# Palo Verde Nuclear Generating Station Units 1, 2, and 3 Auxiliary Feedwater System Reliability Study Evaluation

The purpose of this report is to present the results of the review of the Auxiliary Feedwater System Reliability Analysis for the Palo Verde Nuclear Generating Station Units 1, 2 and 3.

FIGURE 1 AUXILIARY FEEDWATER SYSTEM

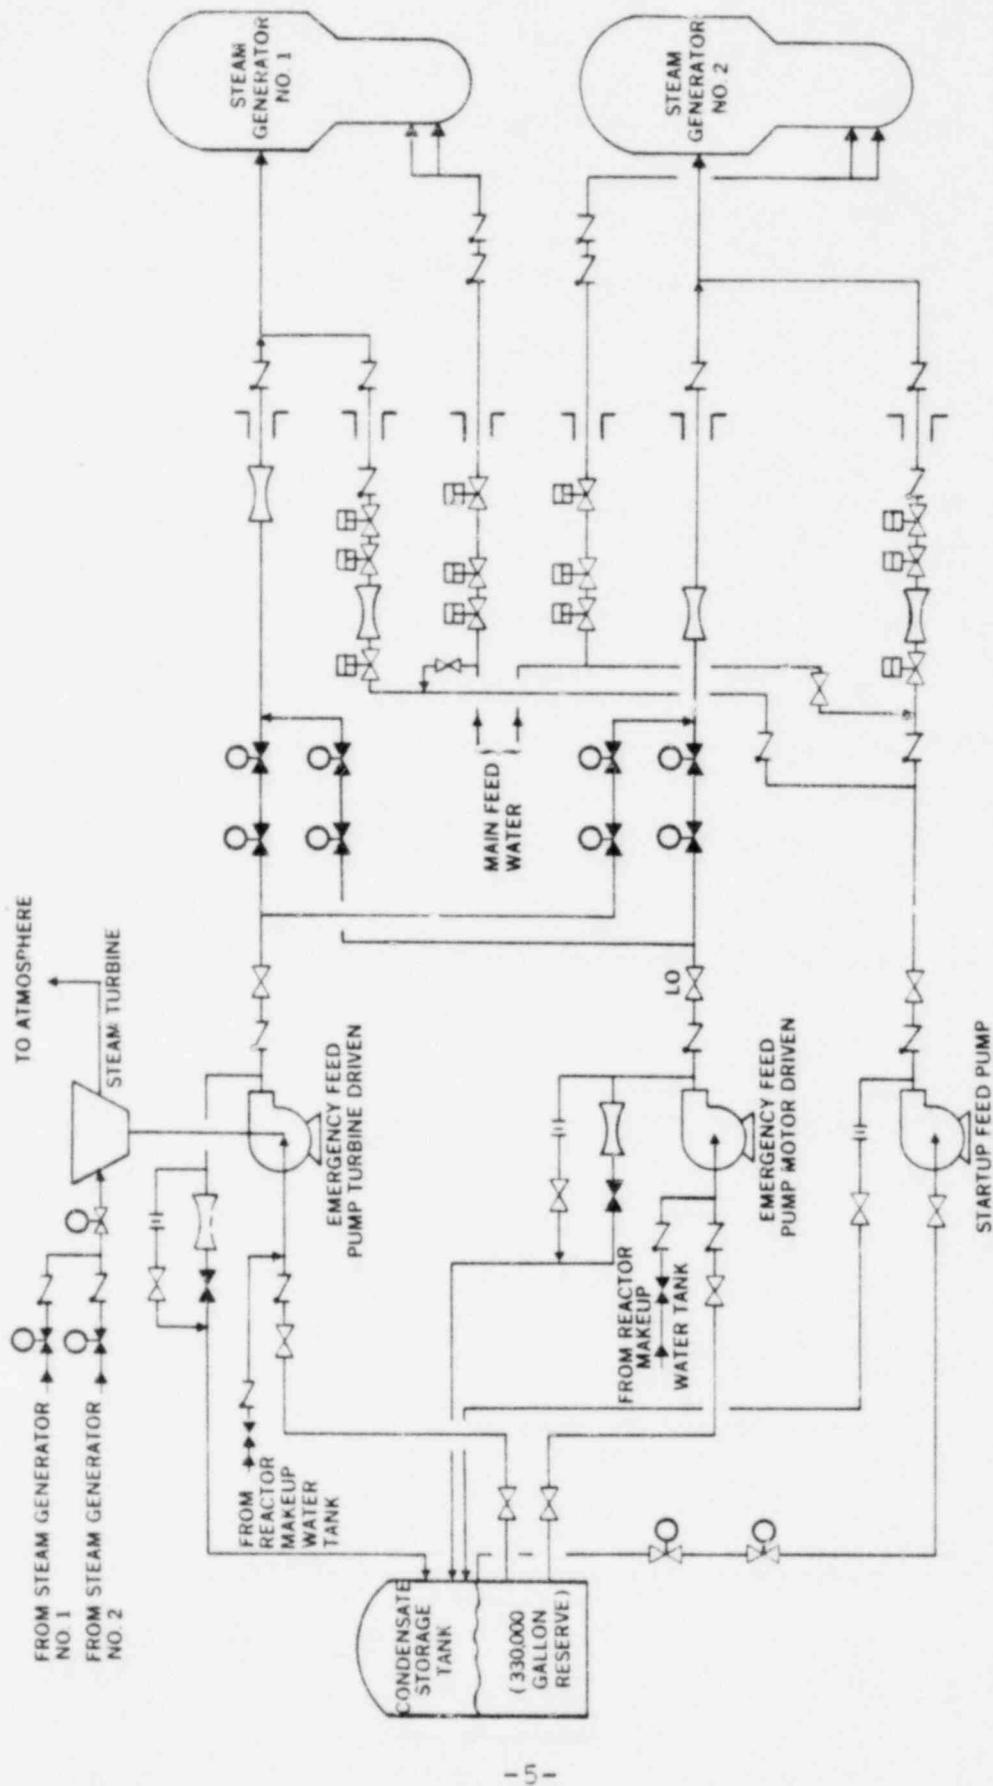
Provide the capability to supply the start-up auxiliary feedwater pump from the train A diesel generator.

Provide position indication in the control room for the pump test bypass valves.

Provide power to the suction valves for the start-up auxiliary feedwater pump from the train A diesel generator.

Perform a total system test once every 18 months.

Perform testing on different shifts.

The design has been modified to incorporate this recommendation.

The design has been modified to incorporate the recommendation.

The design has been modified to incorporate the recommendation.

PVNGS will adopt Technical Specifications to assure that, prior to plant start-up following an extended cold shutdown, a flow test will be performed to verify the normal flow path from the primary AFWS water source to the steam generators.

Having different operators perform surveillance tests on the AFWS will not be required at PVNGS. Surveillance tests are of a frequency and complexity such that the operator will be required to use written procedures to conduct the tests. These procedures will contain appropriate sign-offs and checklists to insure that the testing is conducted in accordance with the procedure.

FIGURE 2

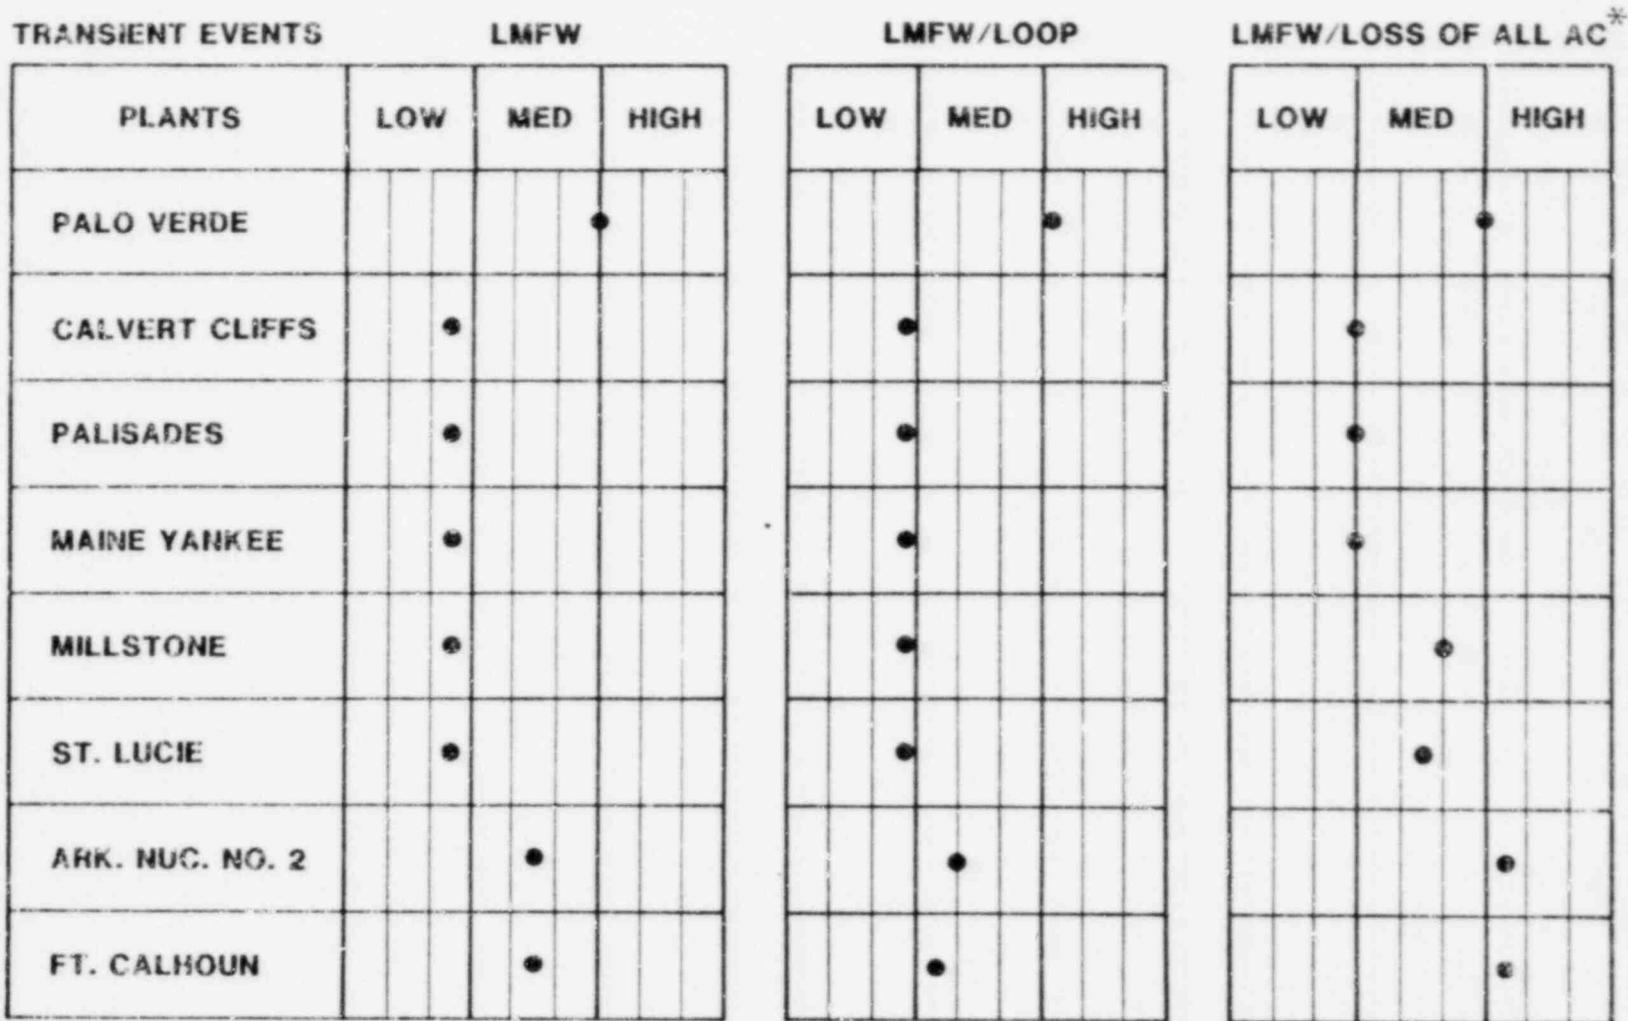
1. Loss of Main Feedwater with Offsite Power Available -- No single failures that would result in insufficient auxiliary feedwater flow were identified. The analysis indicated that the largest unavailability was due to human error. The applicable human errors are inadvertently leaving the pump recirculation valve open after a full flow pump test, and leaving the pump discharge manual valve closed following maintenance on the pump. The unavailability of the AFWS for Case 1 is  $1.3 \times 10^{-4}$  per demand, which places this system in the medium reliability group relative to operating PWRs. Two recommendations that improve reliability for this transient have already been accepted by the utility. These are to provide position indication in the control room on pump-test bypass valves and to have a second operator check manual valve positions following any realignment. Inclusion of these recommendations places the AFWS in the high reliability group.

2. Loss of Main Feedwater and Loss of Offsite AC -- If the diesels have high reliability, the system reliability is approximately the same as Case 1 above. If the diesels have low reliability, the system reliability approaches the

reliability of Case 3 below. For diesel generator failure probability as high as .04 (given as a median number in WASH-1400), the unavailability of the AFWS is  $1.4 \times 10^{-4}$  per demand, which places this system in the medium reliability group relative to operating PWRs. The dominant failure for this case is the same as for Case 1. Inclusion of the two recommendations in Case 1 places the AFWS in the high reliability group for this transient.

3. Loss of Main Feedwater and Loss of All AC -- If all AC power is lost, there is only the turbine driven pump (TDP) available. In this case, the dominant failure is the TDP being out of service due to test or maintenance. The unavailability is approximately  $1 \times 10^{-2}$  per demand, which places this system in the medium-to-high reliability group relative to operating PWRs.

These conclusions are plotted in Figure 2 along with the operating plant ratings which were derived from NUREG-0635.
